***Half Moon Bay/Pillar Point
Ground-Water Basin Report
Phase II***

***Supplemental Data
June 1992***

**SUBJECT: SUPPLEMENTAL DATA FOR THE HALF MOON BAY/
PILLAR POINT GROUND-WATER BASIN REPORT, PHASE II**

RE: Half Moon Bay Airport/Pillar Point Marsh
 Ground-Water Basin Report Phase II

Project No. 3539 Figure No. 3.3

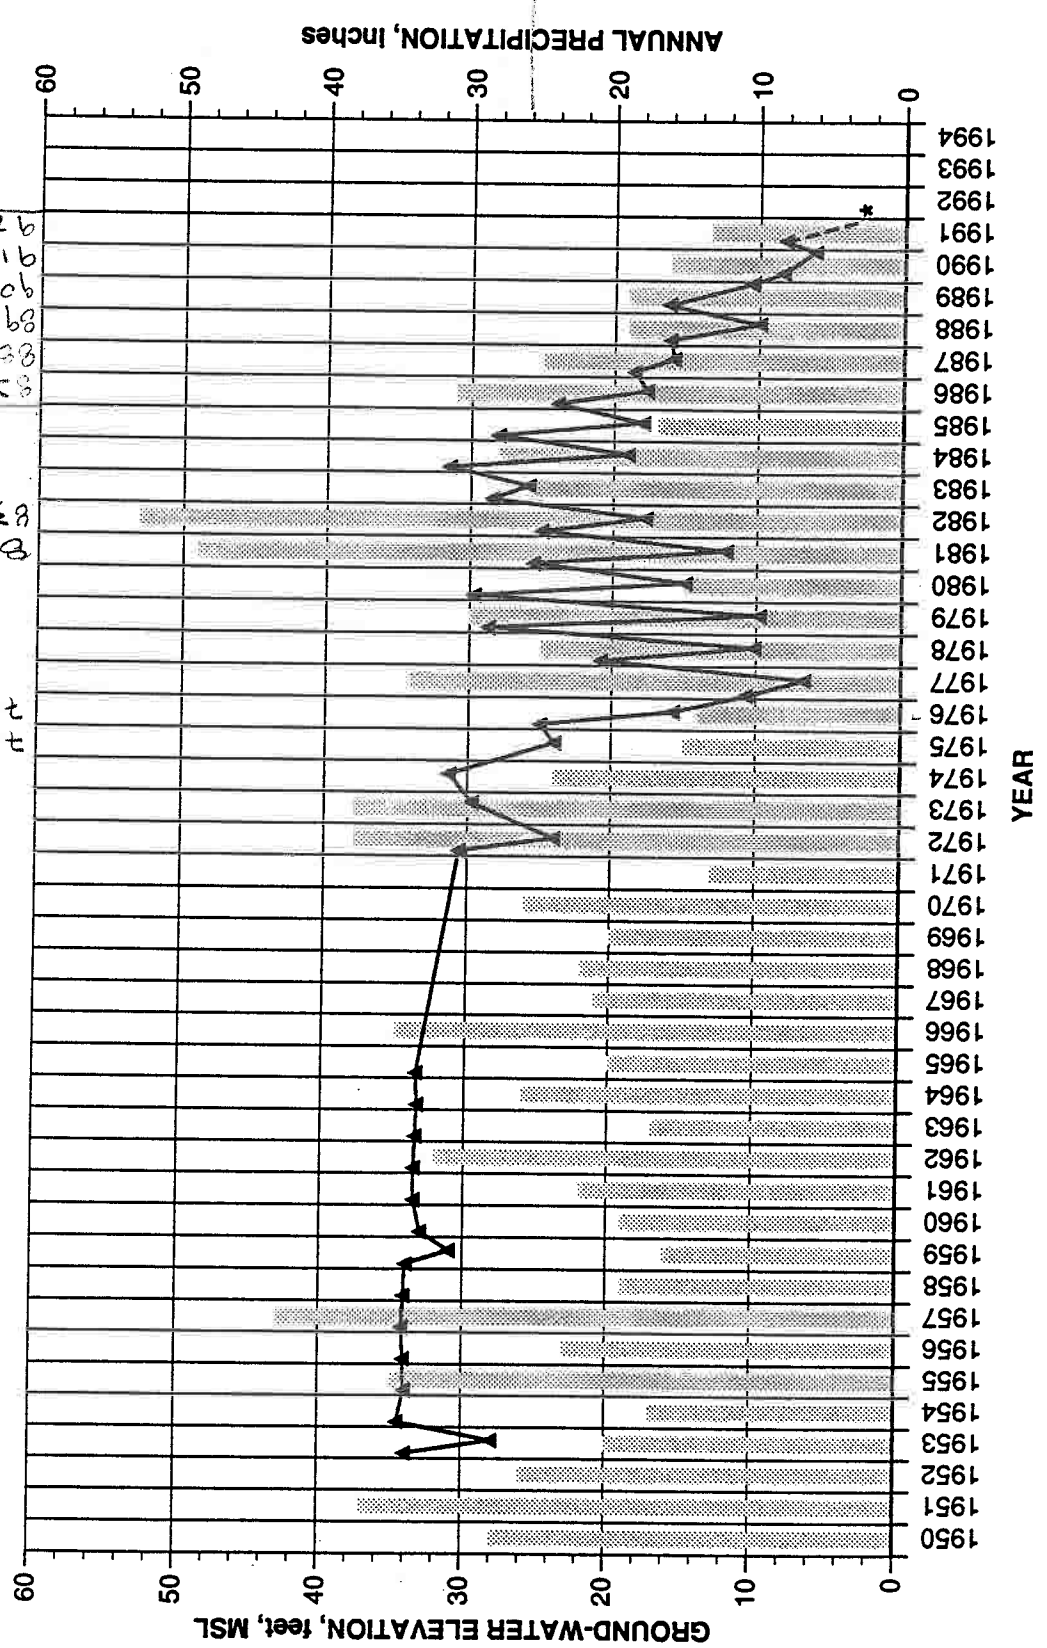
SM1. & SM2. *Request for update of tables and graphs to include the most recent data available, specifically for piezometer ground-water elevations.*

SM1. & SM2. [ESA] The update of requested graphs and tables from the Phase II Pillar Point Marsh Ground-Water Study has been completed. This work included taking new measurements of stream flows and piezometer water levels in the Denniston Creek Basin.

See the attached Tables 3.1, 3.2, 3.3, 3.4 and Figures 3.3, 3.4, 3.6, 3.am, 3.7b, and 3.8. The ground-water hydrograph for M5 has also been updated (no figure number). A hydrograph was not prepared for M7 due to the lack of data for that well which has generally been inaccessible throughout the study period.

Project No. 3539
 Figure No. 3.4

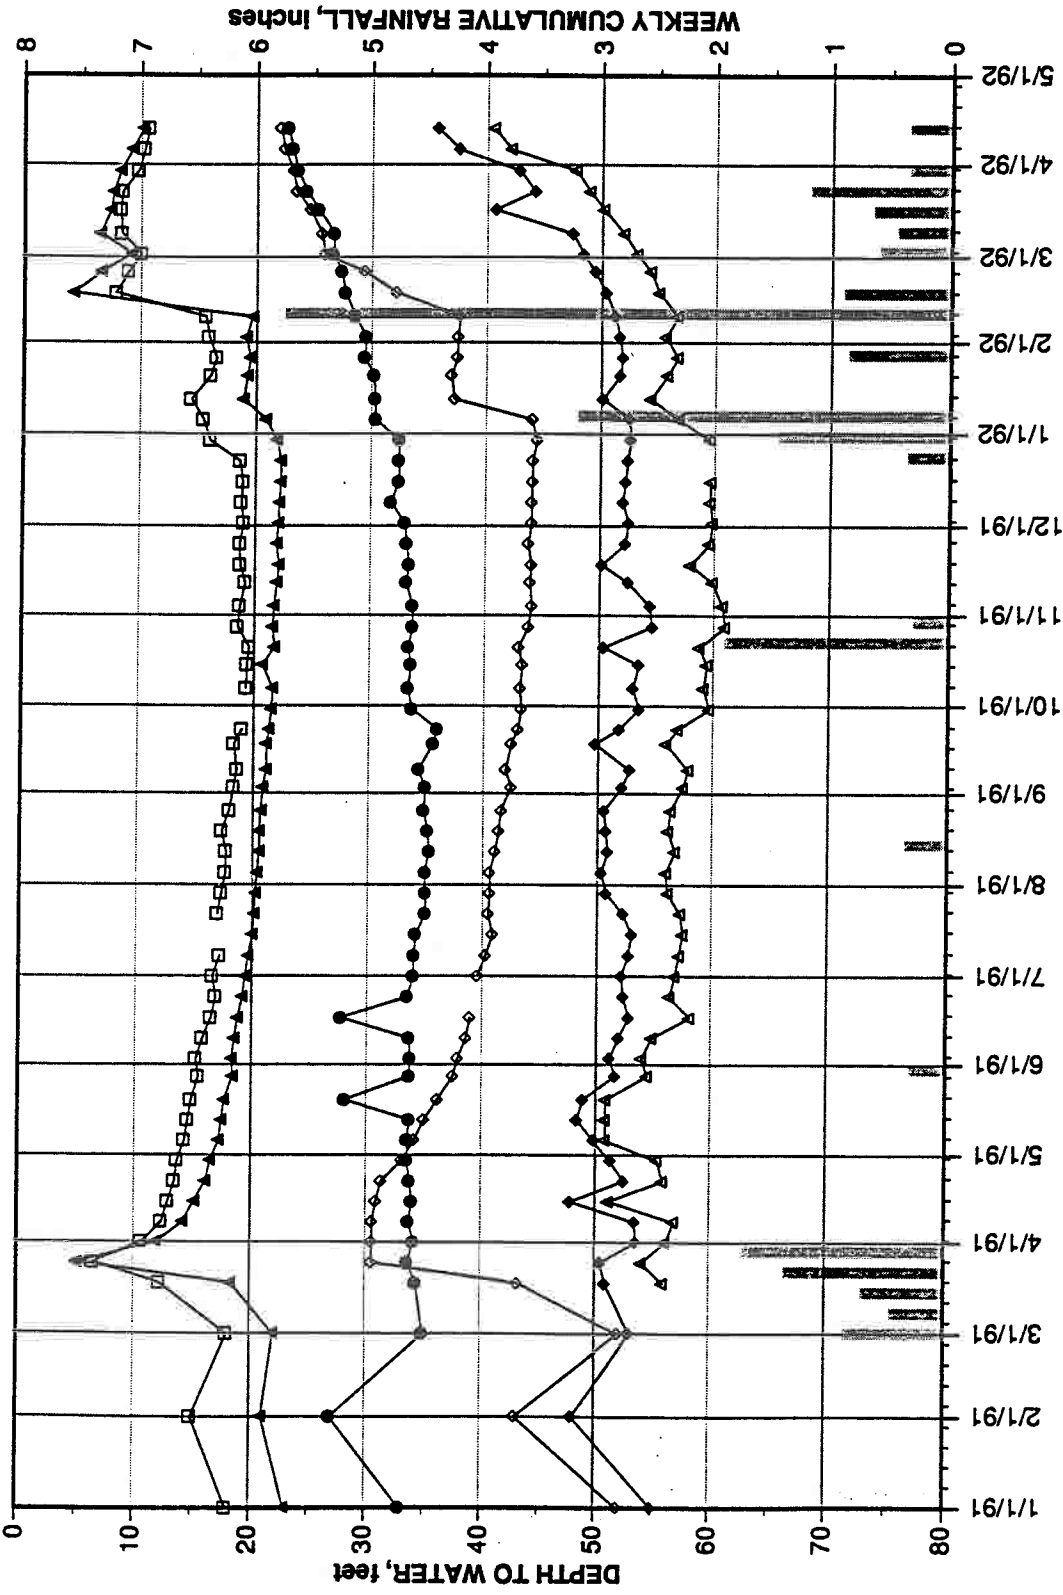
- CC6. Figure 3.4, the ground water elevation hydrograph that compares annual precipitation with respect to ground-water elevation for DWR well 5S/6W-10J1, should be discussed in the text. The ground water elevation appears to have remained rather steady until the early 1970's. Since that time the ground water levels have fluctuated wildly while showing an overall drawdown. Apparently this site passed the equilibrium point, a pumping/recharge balance, in the early 1970's with an overall decline since. It could also be indicative of a sub-basin or fault bounded basin within the basin. This should also be discussed in the text. Note that this well is the DWR well that has gone dry.

CC2. Discuss water level observations for Department of Water Resources monitoring well 5S/6W-10J1 (Figure 3.4)

CC6. Discuss Figure 3.4 showing ground-water elevations for DWR well 5S/6W-10J1 relative to annual precipitation.

CC2. [ESA/LSCE] - Following precipitation events during 1991 to 1992, there has been a substantial increase in ground-water elevations throughout the basin. All of the hydrographs show rising ground-water levels in 1992. As discussed in the Phase II report, page 11, "water levels within the basin have recovered seasonally, except during periods of temporary drought. Figure 3.4 (the hydrograph for the DWR well) illustrates the recovery of ground-water levels with increased precipitation following the drought of 1976 and 1977." It is expected that water levels in the DWR well (had it not been abandoned) would have exhibited increases consistent with the basin wide increase in ground-water elevations.

CC6. [LSCE] - See comments under Item CC2. The ground-water elevations depicted in Figure 3.4 do not exhibit an overall decline since the early 1970's. Following the middle to late 1970's drought and the subsequent above normal precipitation of the early 1980's, ground-water elevations in 1984 were comparable to elevations observed from 1953 to 1965. Declining ground-water elevations during 1987 through 1990 reflect the affect of drought conditions.

Checked By _____	Date _____	Project No. 3539	Figure No. 3.6
Approved By _____	Date _____

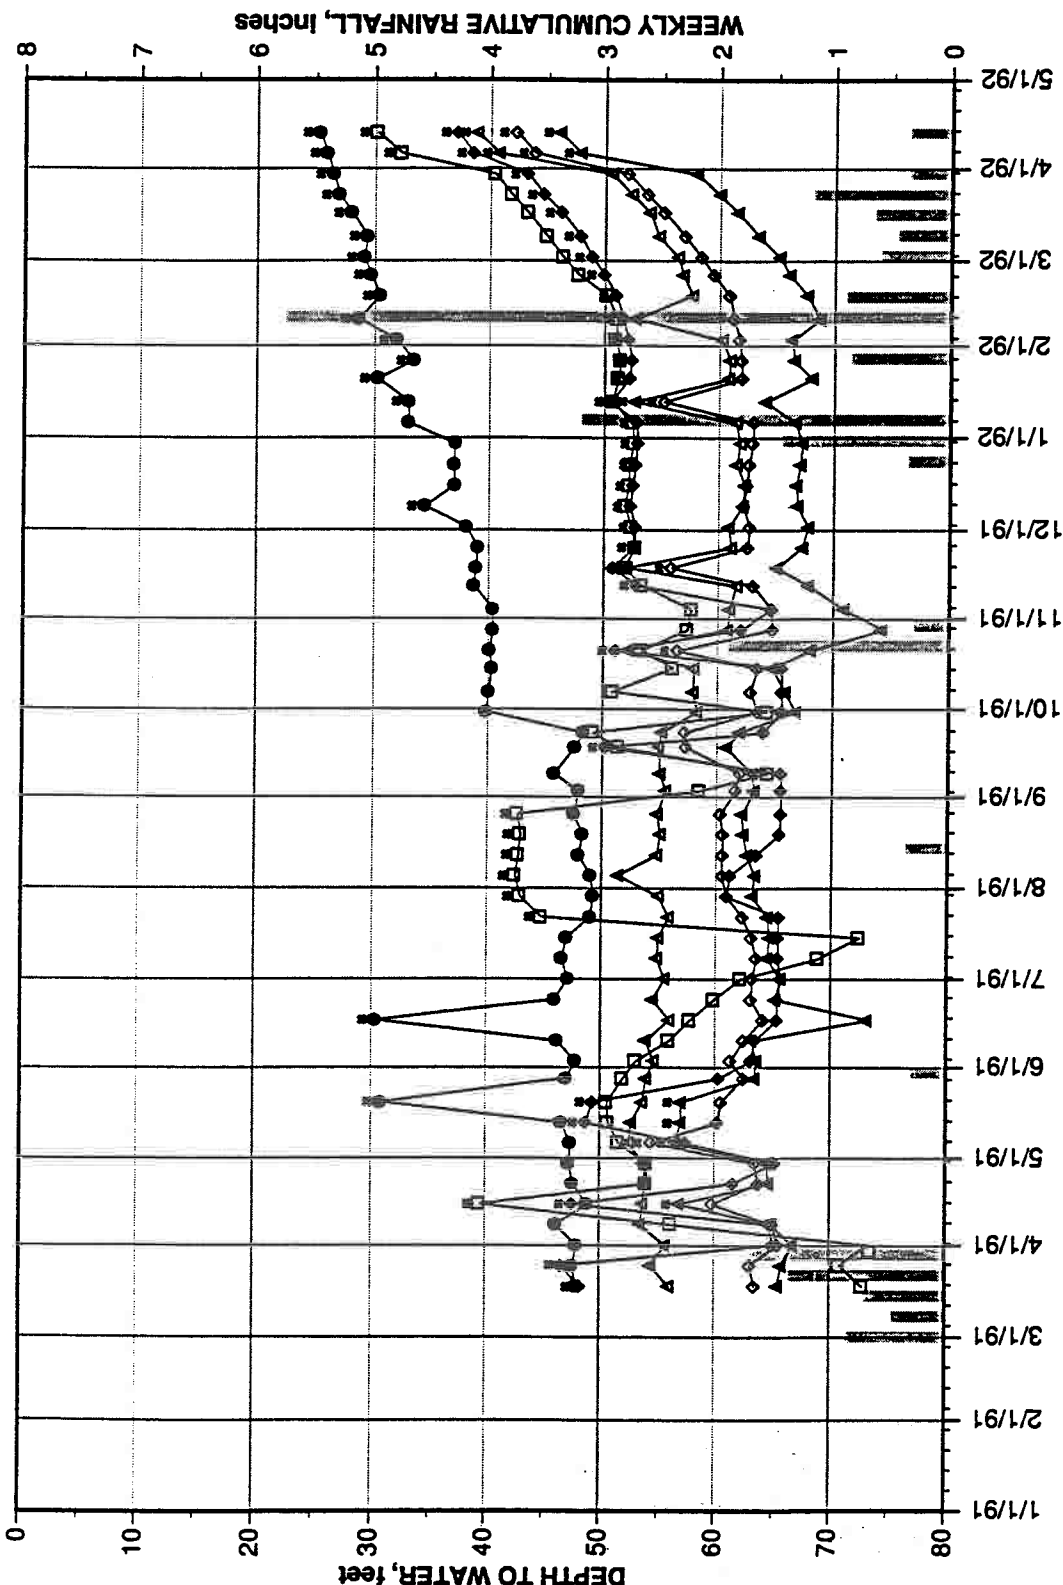
- CC7. Figures 3.6 and 3.7 should show a full year of ground water elevations to determine if there is a seasonal fluctuation reflected on the overall downward trend. January to June does not constitute a hydrographic year and does not show the critical time that occurs much later in the season from August to November.

CC7 Update Figures 3.6 and 3.7 to show seasonal or other ground-water elevation trends.

CC7. [ESA] - See Attachment; Figures 3.6, 3.7, 3.7a and 3.7b.

Checked By: _____ Date: _____
 Approved By: _____ Date: _____
 Project No. 3539 Figure No. 3.8

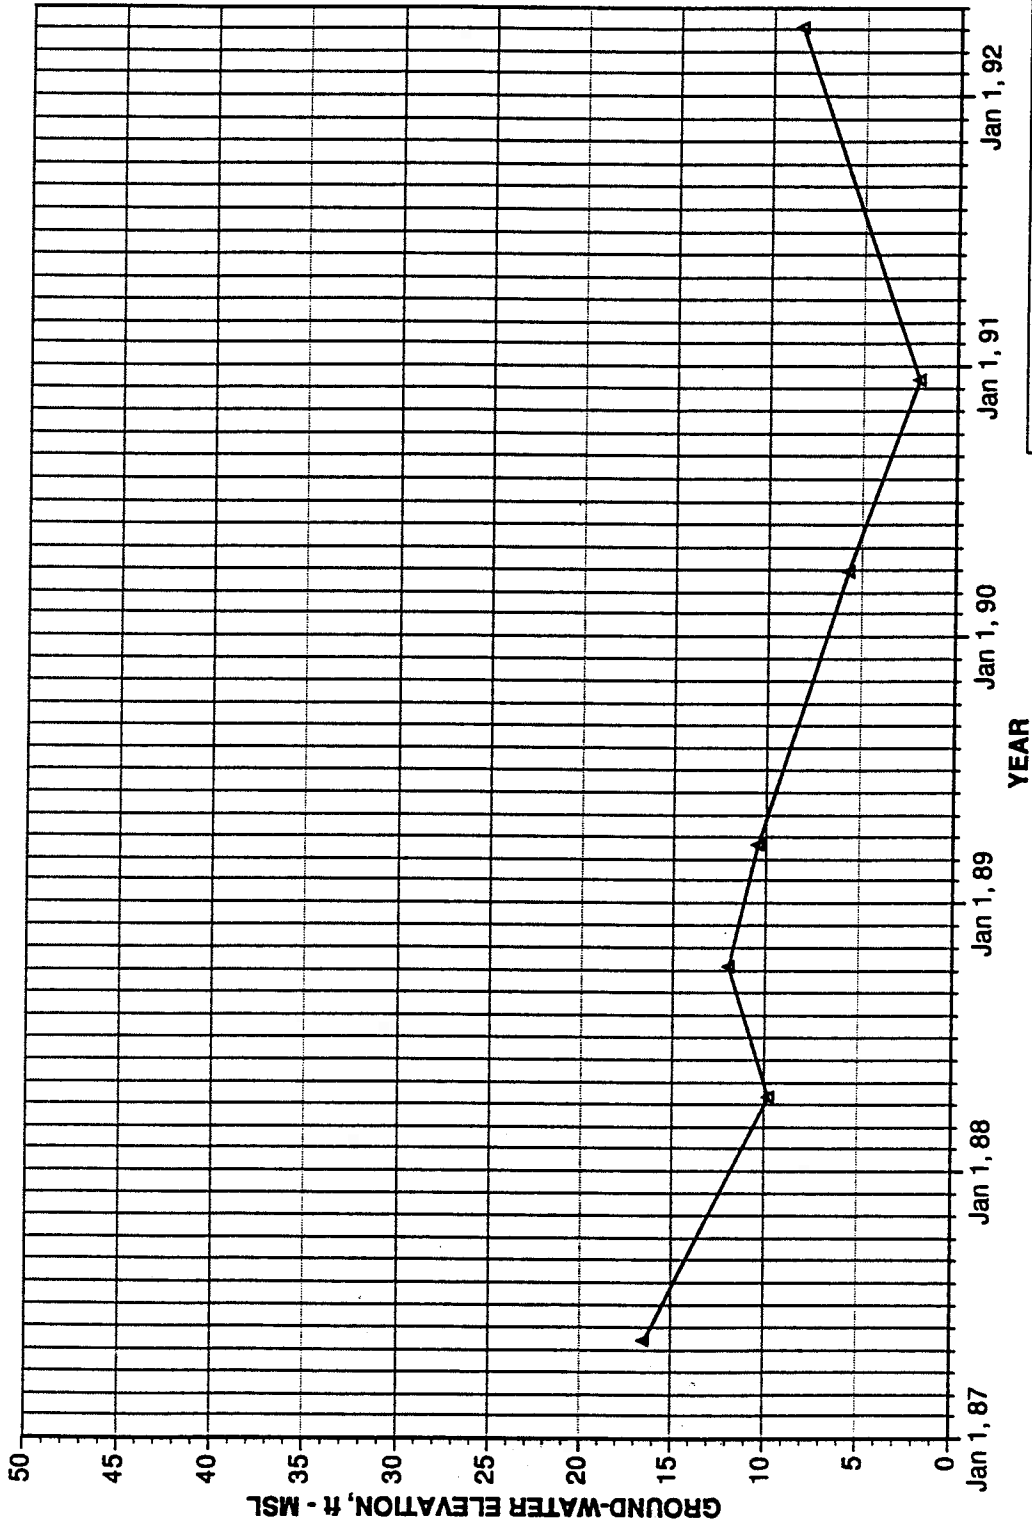
- SM1** • An update of the tables and graphs to include the most recent data available specifically for the Piezometer Groundwater Elevations (Table 3.4).
- SM2** • An update of the hydrographs for Monitoring Wells M5 and M7.
- SM3** • A final determination of how many wells exist in the basin and their approximate location and depth.
- SM4** Additionally, after your presentation at the February 11, 1992 hearing, Mr. William Rozar and I had an opportunity to discuss your statement that a "small scale well drilled a reasonable distance from the marsh and coastsides may not have a negative impact on the marsh." You indicated that this information could be compiled in a table which would assist in the review of two pending Coastal Development Permits which were filed with our department prior to the release of Phase II of the Pillar Point Marsh Groundwater Basin Report.

The recent water levels measured in the piezometers show that an upward vertical

ground-water gradient still exists. This indicates that ground water continues to recharge the marsh, and that the marsh apparently has not been adversely affected by pumping of existing production wells.

FIGURE 3.2

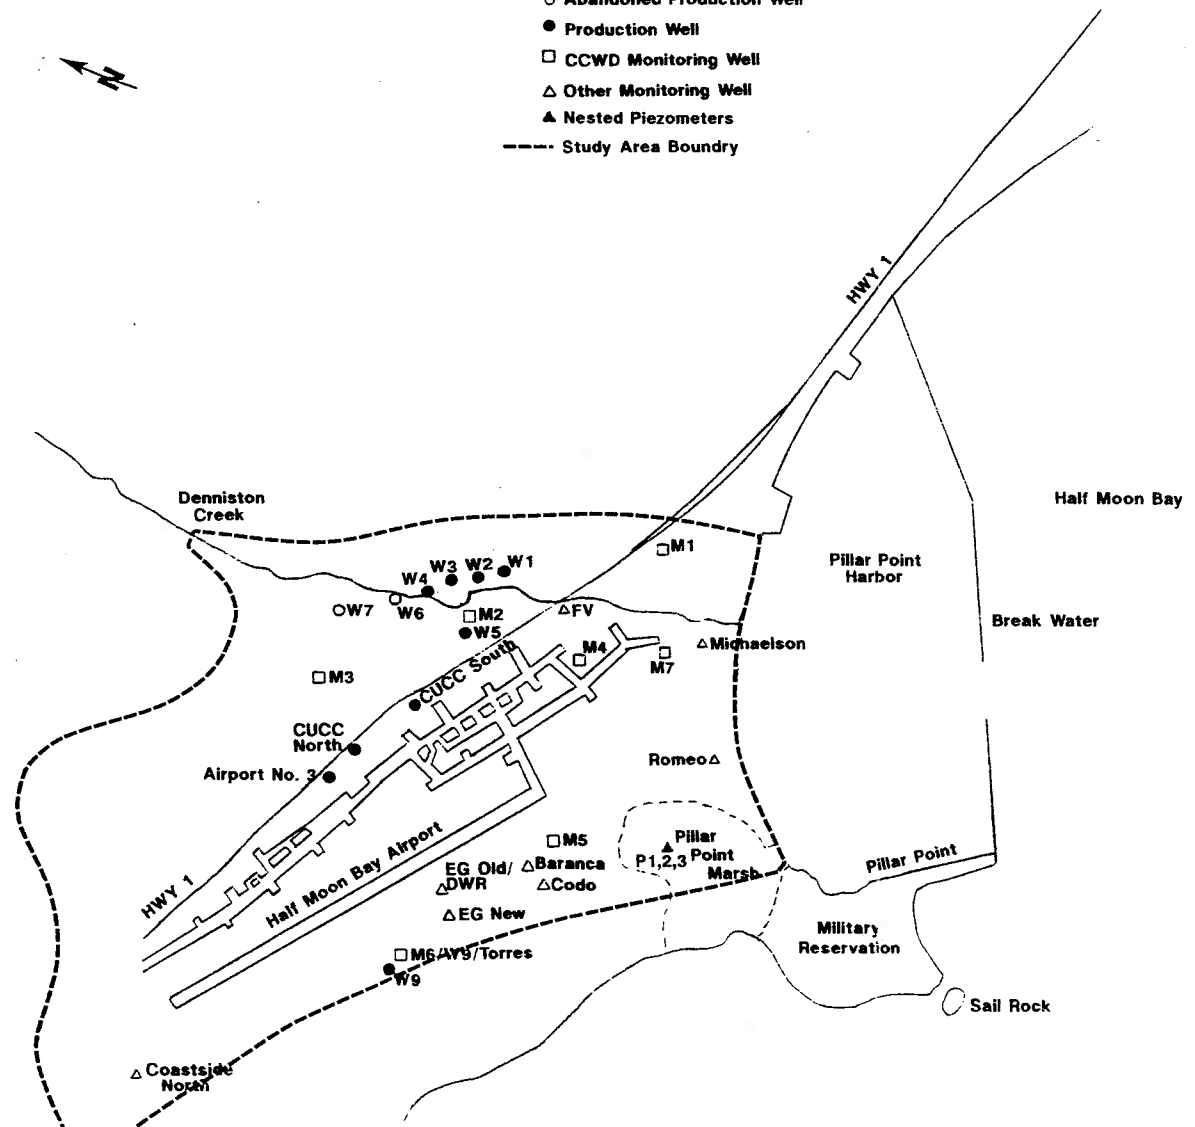
- CC4a. Figures 3.1 and 3.2 showing well locations would be much more useful if the ground-water basin boundaries were shown. It is helpful to use the same base map for all site locations, geology, and water elevations so they can be used together, to determine any interactions. A geologic map should be included showing the physical boundaries of the basin such as faults and contacts.

CC4a. Show ground-water basin boundaries on Figures 3.1 and 3.2.

CC4a. [LSCE] - The purpose of Figure 3.1 was not to show well locations but to show the Denniston Creek survey locations. That figure only illustrates a portion of the basin; therefore, no basin boundaries were shown. Figure 2.1 in the Phase II report illustrates the study area boundaries. Figure 3.2 has been updated to illustrate the basin boundaries (attached).
